ALTA MESA WIND PROJECT EA-IS

Responses to Comments

February 2021

Figure 4: Size of cocci spores compared to soil particles (in mm)
(from: Fisher et al., 2007, Fig. 3)

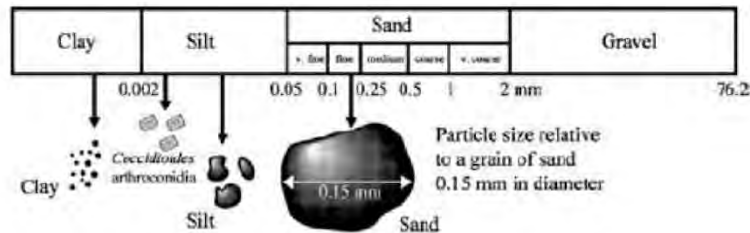
The potentially exposed population is much larger than construction workers on or adjacent to the Project site because dust generated during Project construction will carry the small spores – 0.002-0.005 millimeters in diameter – into other areas, potentially exposing large segments of the public.^{12,13}

Valley Fever spores have been documented to travel as far as 500 miles¹⁴ and dust raised during construction has the potential to expose people located miles away.
